## **Addendum 5**

#### **RFTMA26-5334 - New School Construction Mayfield West No. 2 Public School**

**PROJECT NO. 24112**

**ADDENDUM NO. 5**

SCHEMATIC IRRIGATION PLAN

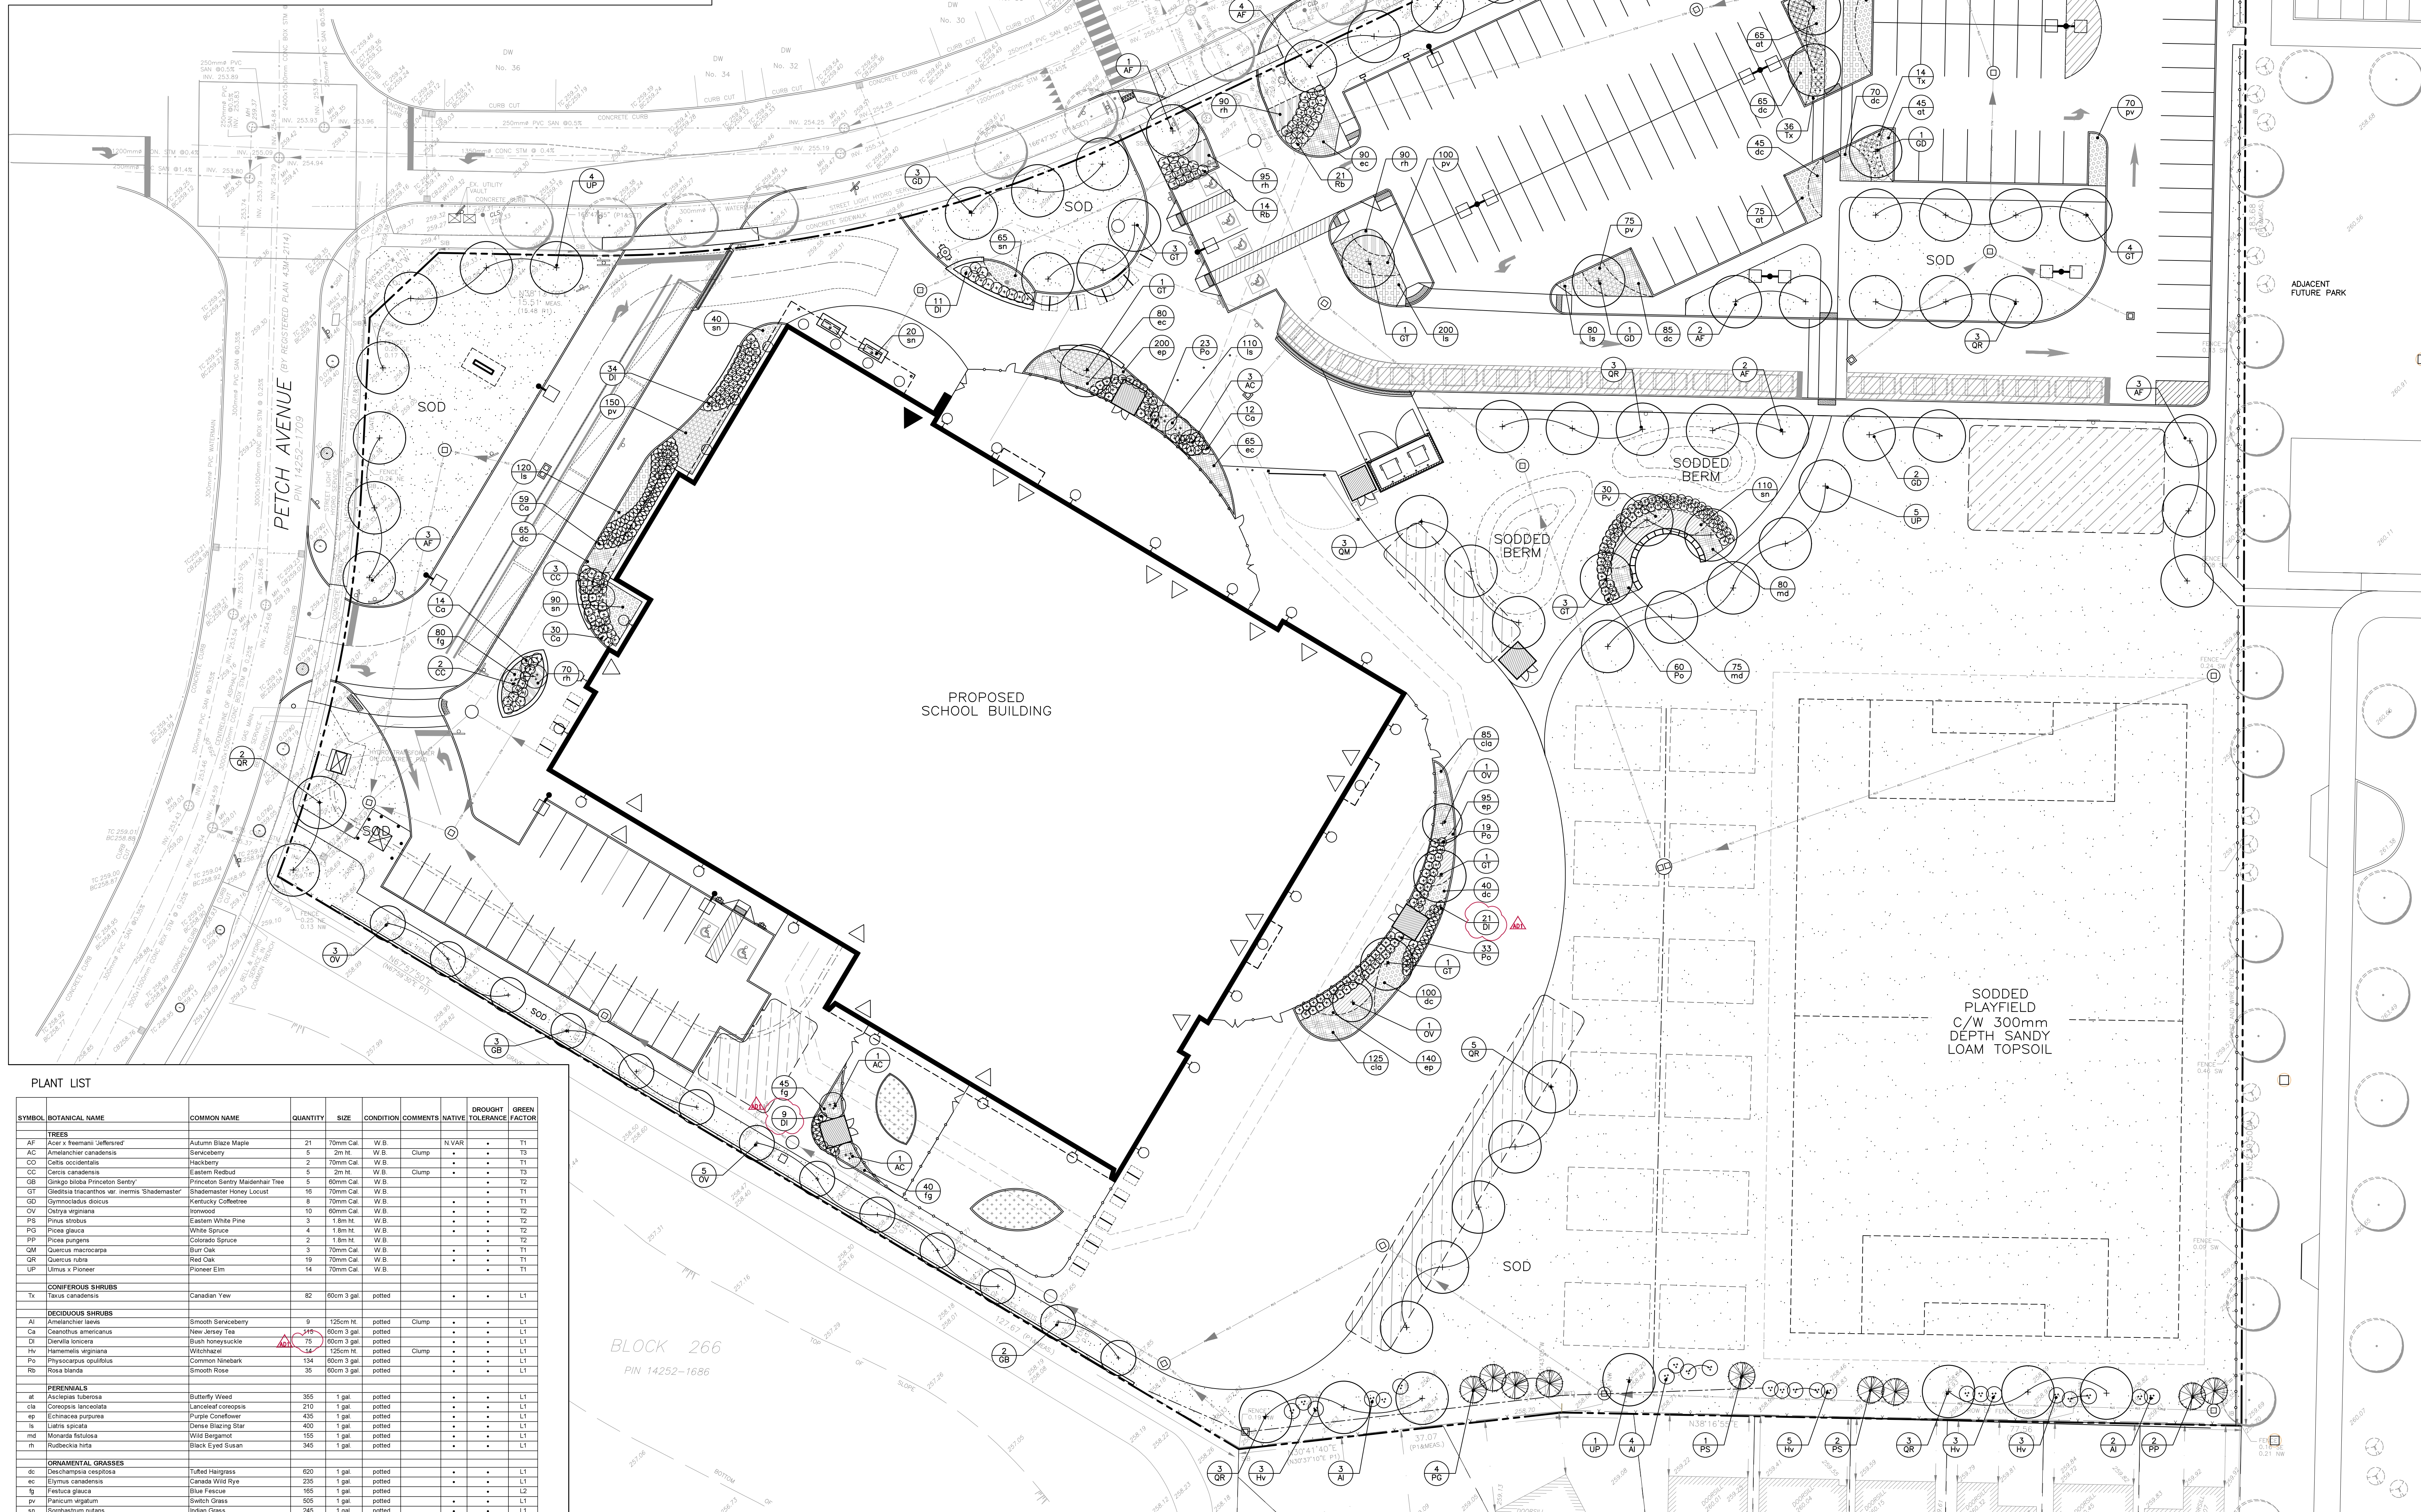
- .3 Revise location of master control valve to be located within the building.
- .4 Revise legend and plan graphics depicting, irrigation water meter, flow sensor and master valve.

- .5 Revise Detail 1 Water / Electrical Supply Schematic to include;
  - .1 Addition of irrigation water meter. Refer to Mechanical
  - .2 Addition of CAT6 ethernet wiring to controller. Refer to Electrical.

## PLANTING PLAN

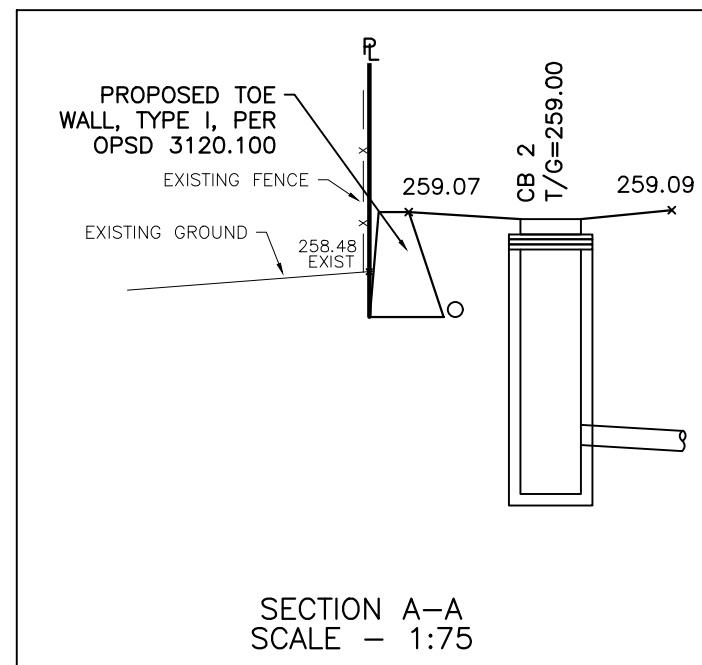
- .6 Revise quantity of Diervilla lonicera shrubs in outdoor childcare and kindergarten play areas to accommodate shifted sheds per site plan.

majority of street trees within the boulevard of Tweedhill Avenue are to be completed by the developer. Within the scope of this project, two additional *Celtis occidentalis* trees are proposed within the Tweedhill Avenue boulevard, as noted on the L200 Planting Plan.

**R14 SECTION**  
SS-02 1:20

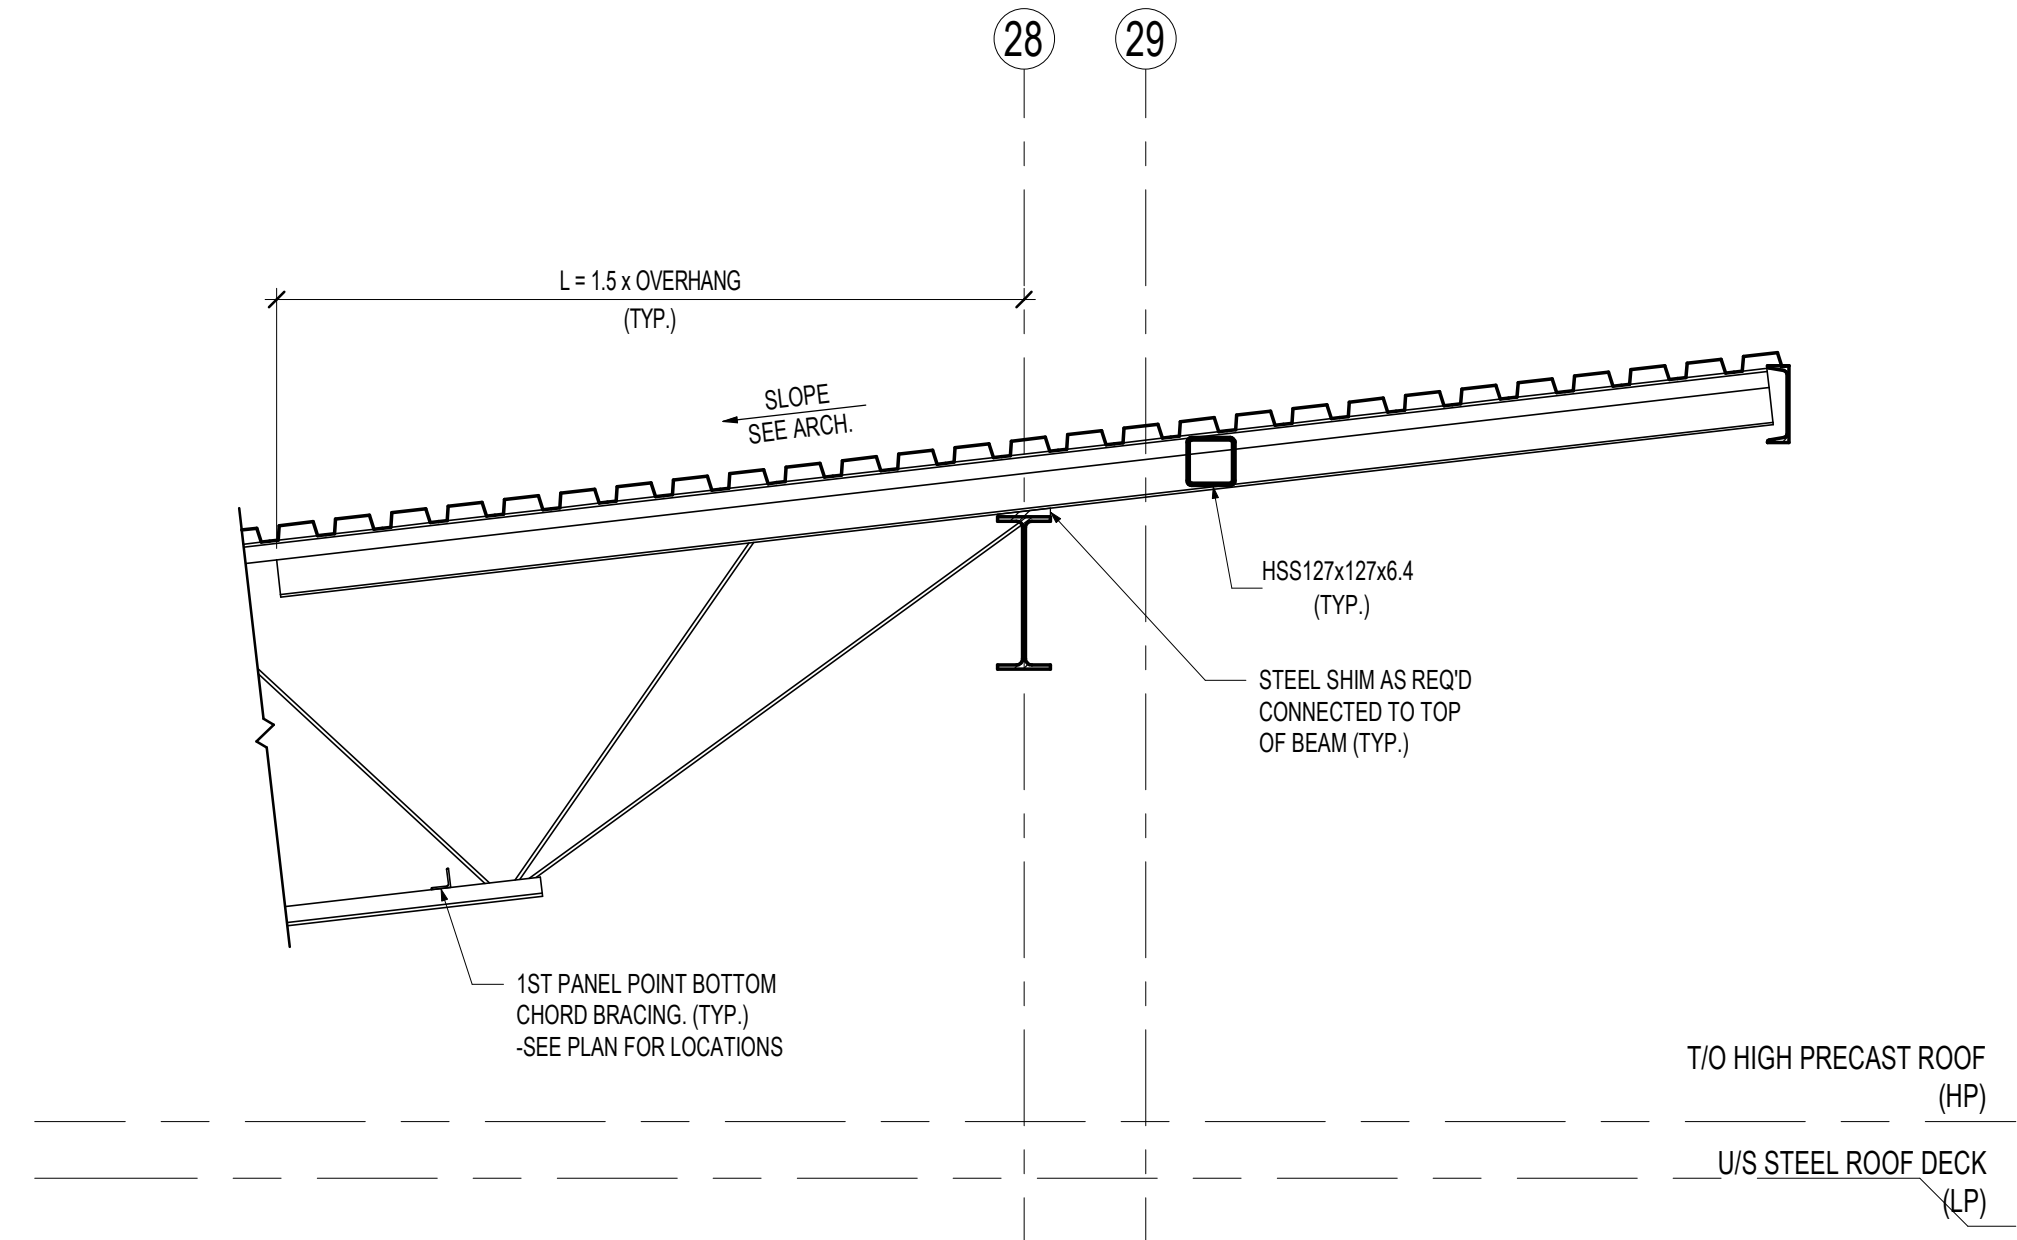
QUESTION 10: Please advise if any special deflection will be used for the joists supporting folding partition as per section R14/S5-02

- .1 Deflection limit note added to section R14. See clouded area.

ANSWER 10: 25mm max. Refer to enclosed Structural Addendum No. 2 dated July 29, 2026. Attached.
